Subject: **Upland Restoration Plan – Revised**

NYSEG Plattsburgh (Saranac Street) Former MGP Site, Operable Unit No. 1
NYSDEC Site No. 5-10-007

Comments and Responses

CULVERT PROFILE 1
(2X VERTICAL EXAGGERATION)

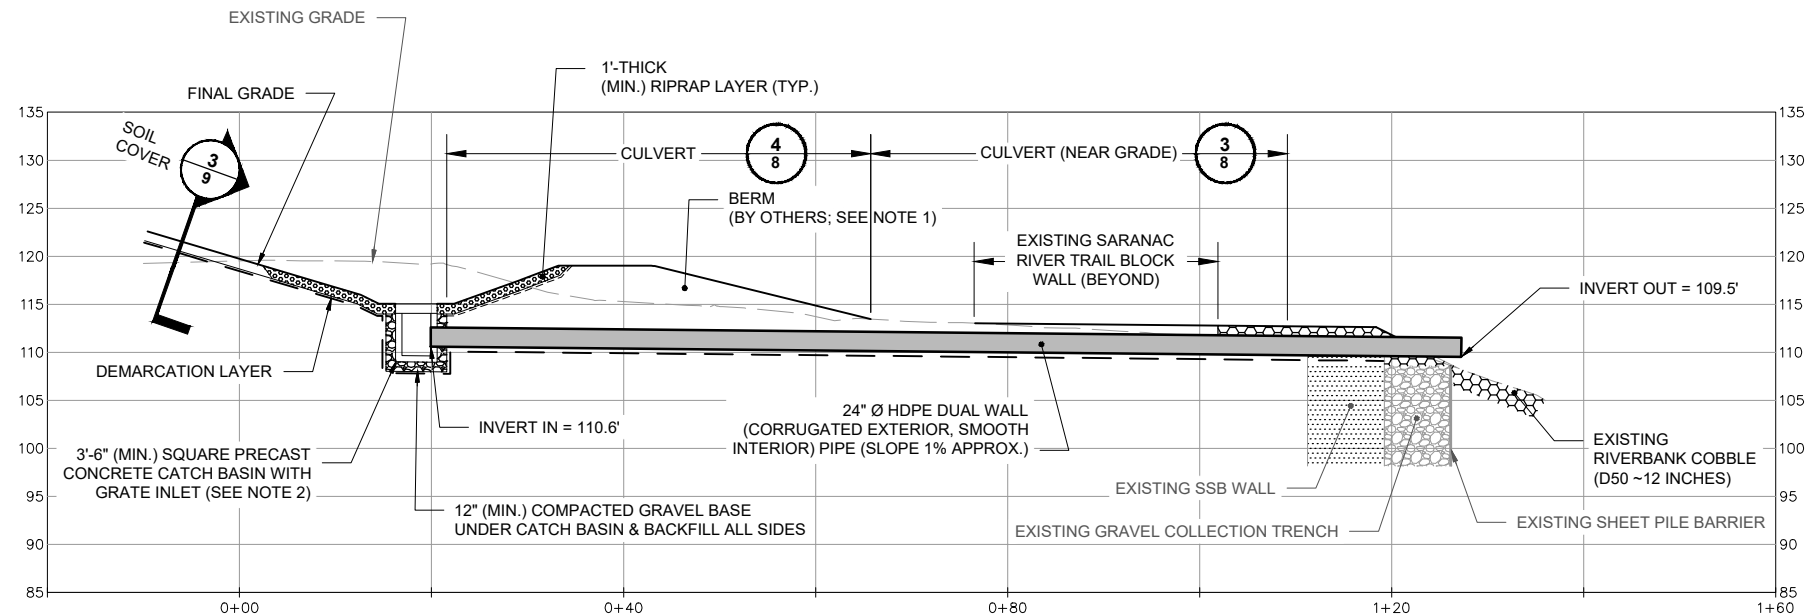
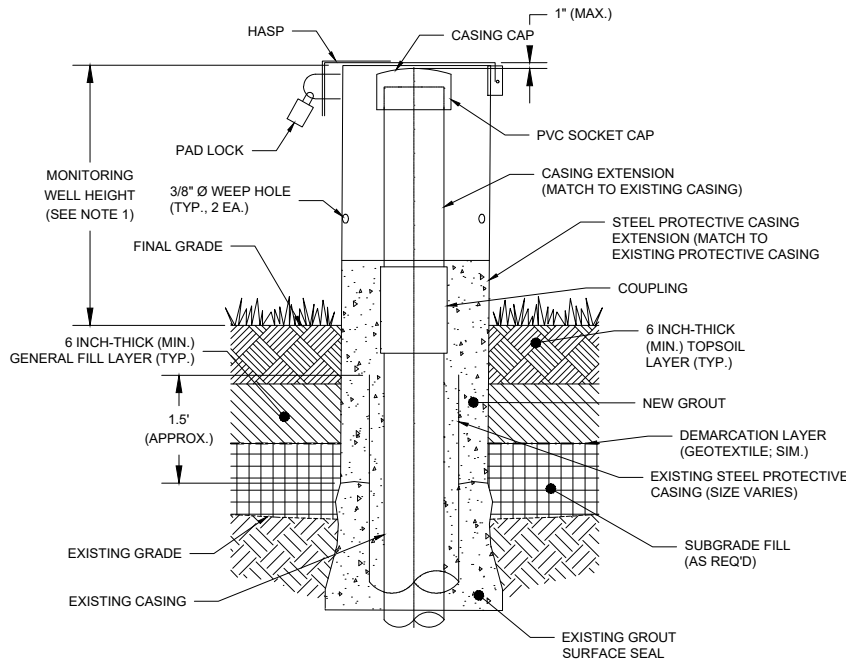
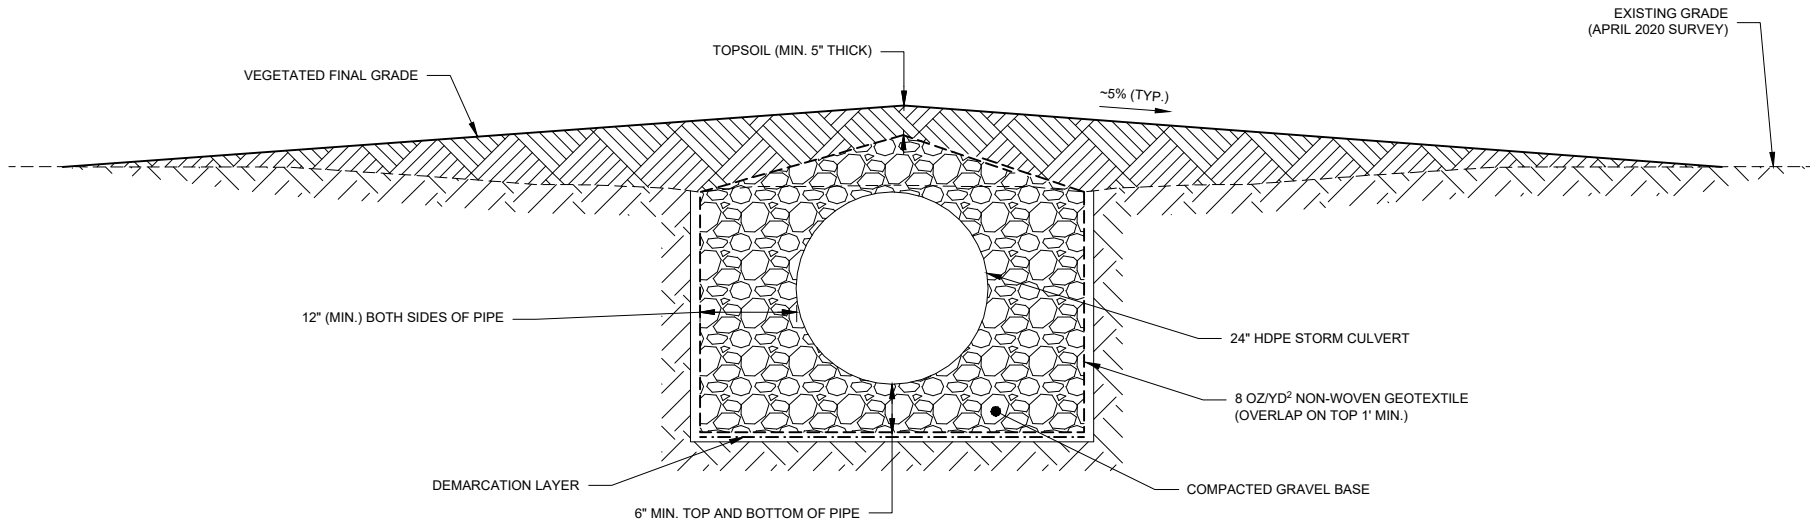
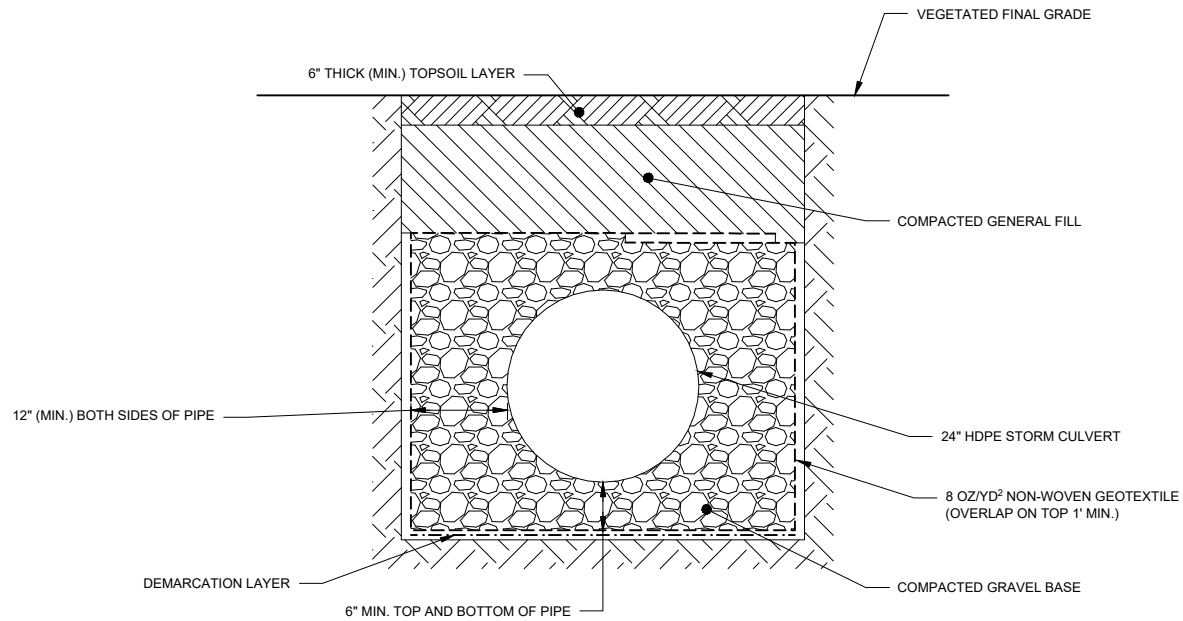
Comment 1, General: Please note the installation of the culvert into the bank will likely require coverage under a Water Quality Certification. If so, this should be specified in the work plan.

Section 3.6 was added to note that installation of the catch basin and culvert require coverage under a WQC and that NYSEG obtained a WQC modification in a letter from the NYSDEC dated June 23, 2022. The permit modification along with the original permit are included in Attachment F.
